COLORADO DIVISION OF RECLAMATION, MINING AND SAFETY
MINERALS PROGRAM INSPECTION REPORT
PHONE: (303) 866-3567

MINE NAME: Gravel Pit No 7	MINE/PROSPECTING ID#: M-1977-484	MINERAL: Sand and gravel	COUNTY: Baca
INSPECTION TYPE: Monitoring	INSPECTOR(S): Amy Eschberger	INSP. DATE: November 19, 2014	INSP. TIME: 13:00
OPERATOR: Robins Redi Mix, LLC	OPERATOR REPRESENTATIVE: James Adams and Kurt Eskew	TYPE OF OPERATION: 112c - Construction Regular Operation

This was a normal monitoring inspection of the Gravel Pit No 7 (Permit No. M-1977-484) conducted by Amy Eschberger of the Division of Reclamation, Mining and Safety (Division). The permittee, Mr. Rodney Robins was notified of the inspection, but was unable to attend. Mr. James Adams and Mr. Kurt Eskew of Baca County District #3 were present for the inspection. The site is primarily operated by Baca County although the permit was transferred to Robins Redi Mix, LLC with the approval of a Succession of Operators (SO-01) on 09/19/2011. The site is located approximately 9.5 miles west of Springfield, Colorado, in Baca County, on land owned by C.F. & R.M. Cooper Trust. The site can be accessed from the east by a gated entrance off of Co Rd 1

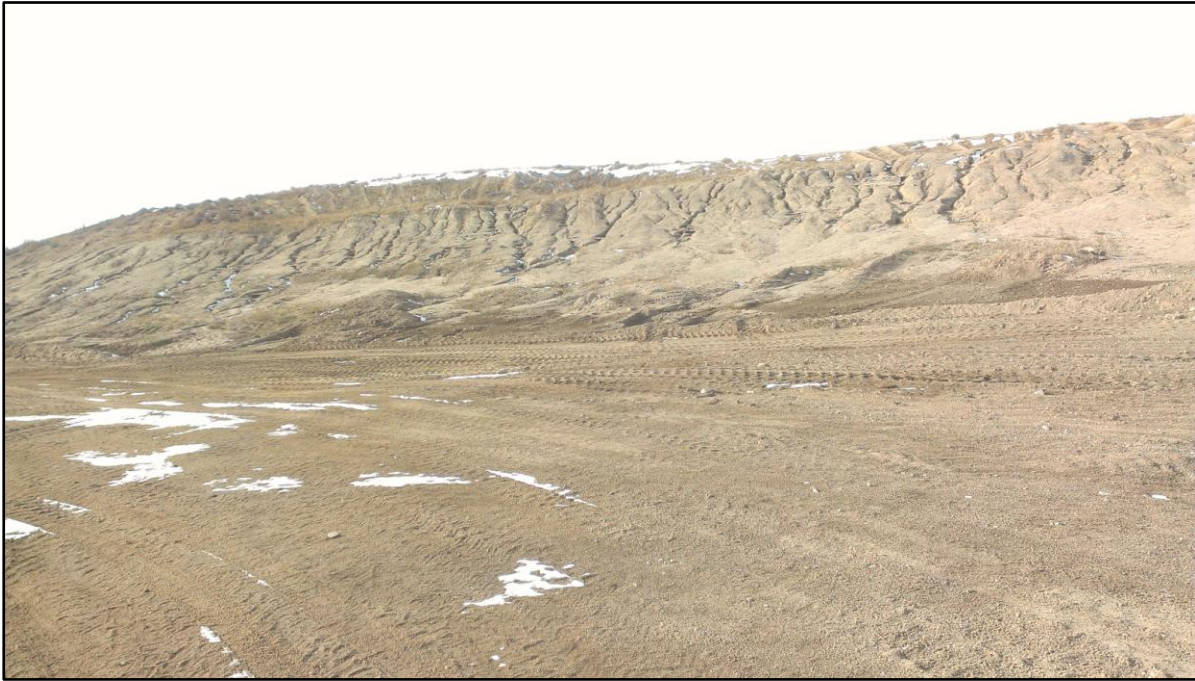
A portion of the southwestern pit wall, approximately 450 feet in length, was graded to slopes of 2H:1V (Photo 6; also see enclosed Google Earth image). The financial warranty currently held for this site includes costs for grading this slope to the approved 3H:1V gradient. Mined material is stockpiled on the pit floor (Photo 7). Salvaged topsoil is stockpiled in berms around the top edges of the pit and they appear to be stable (see Photos 3 and 4). A waste rock stockpile containing up to boulder sized rocks is present in the southwestern portion of the site, adjacent to the pit haul road (Photo 8). This stockpile appears to be stable; however, before the site can be released, this material will need to either be used for backfilling the pit or be graded to slopes of 3H:1V or flatter and revegetated.

Photo 6. View looking west from haul road, showing portion of southwestern pit wall graded to approximately 2H:1V. This wall will need to be graded to 3H:1V or flatter before final release.
